Access Compliance Report

Public Rights-of-Way

| Intersection ID: 43869 | Main Street: CALDWELL_RIDGE_PY | Cross Street: SIDNEY_CREST_AV | Location: SE |
| ADA ID: 6FD48E16C03E | Ramp Type: Perp | Initial Pass/Fail: Fail | Overall Compliance: No |

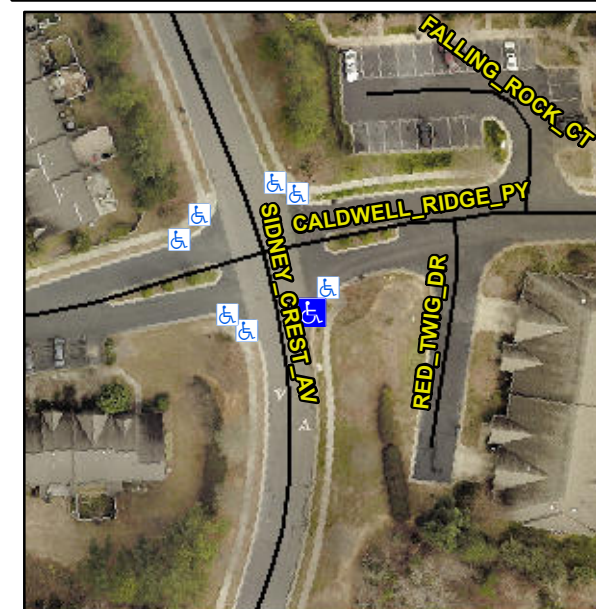
Not Found, R304.5.1, R304.5.3

| Compliance | Description | Data | Compliance | Description | Data |
|------------|-----------------------|------|------------|-----------------------------|------|
| No | Ramp Width (in) | 42.5 | No | Ramp XSlope (%) | 2.3 |

Remove & Replace Entire Ramp.
